STAFF RECOMMENDATION

1310 Ordway Place

March 15, 2017

Description of Project: Application is to construct a detached modular classroom attached to the historic building at an existing side door.

BUILDING NORTH / SOUTH ELEVATIONS	
Project number	-
Date	02/25/2017
Drawn by	CHUCK KEEL
Checked by	
A102	
Scale 1/8" = 1'-0"

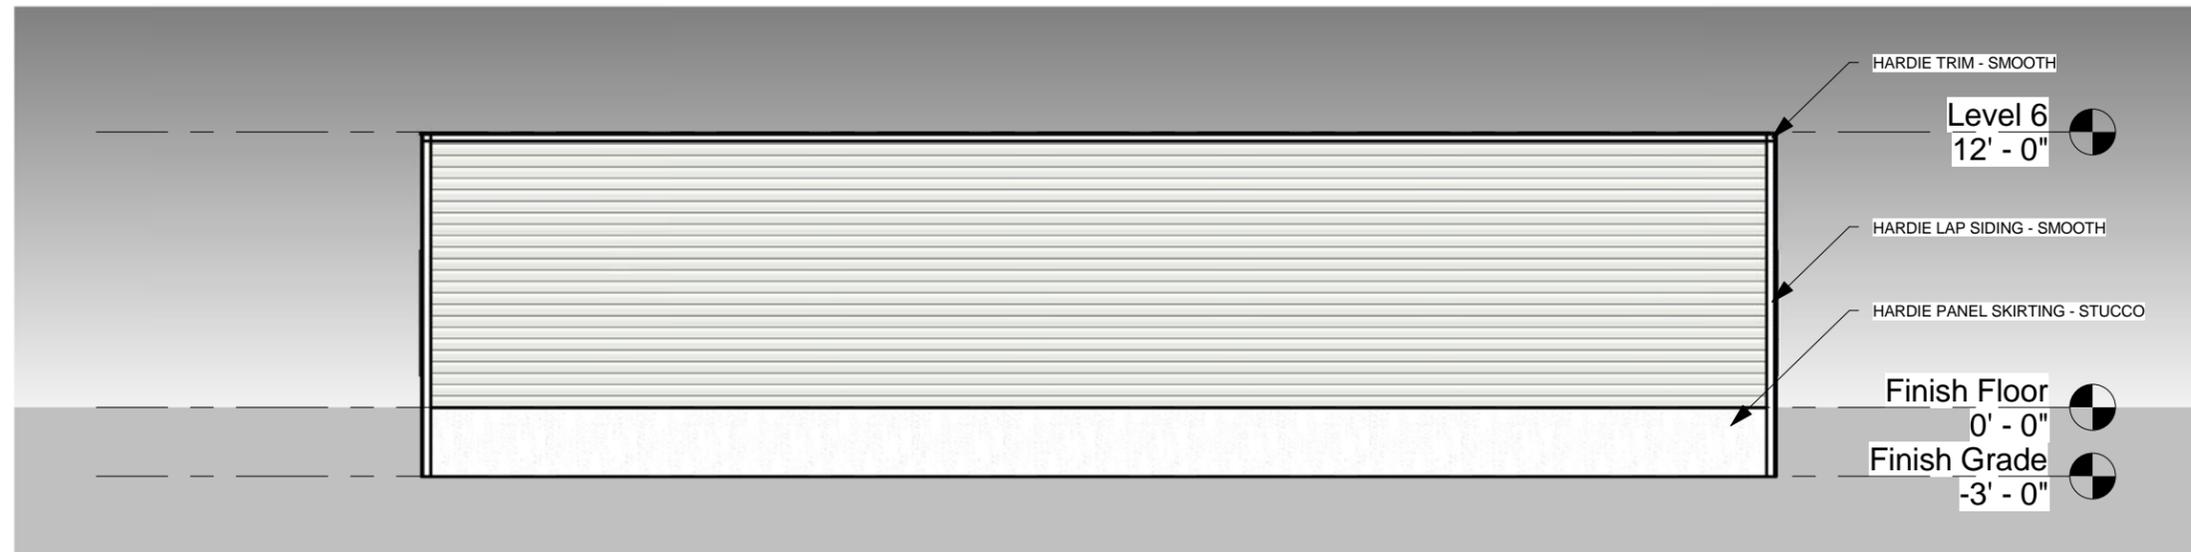
Proportion and Rhythm of Openings & Orientation: The modular will have solid metal doors facing the school and full-light double doors facing North Fourteenth Street, which is appropriate. The front of the building, facing Ordway Place, has no openings. In order to meet the requirement that new construction match the rhythm of solid-to-voids found in the neighborhood, Staff recommends at least four windows on the Ordway facing facade. In order to meet the design guideline requirement for orientation, staff recommends a set of double doors with decking and stairs facing Ordway Place. (The doors do not need to be operable.) Windows may remain on the right-side, facing the historic building, or may be removed, as this will not be a highly visible location. Doors may remain on the left side or be replaced with a window, as this is a secondary façade. With these conditions, the project meets Section II.B.7. and II.B.10. of the *Lockeland Springs-East End Neighborhood Conservation Zoning Overlay: Handbook and Design Guidelines*.

Staff recommends approval with the condition that windows and doors are added to the Ordway Place elevation. With that conditions, Staff finds that that the project meets Section II.B. of the *Lockeland Springs-East End Neighborhood Conservation Zoning Overlay: Handbook and Design Guidelines*.
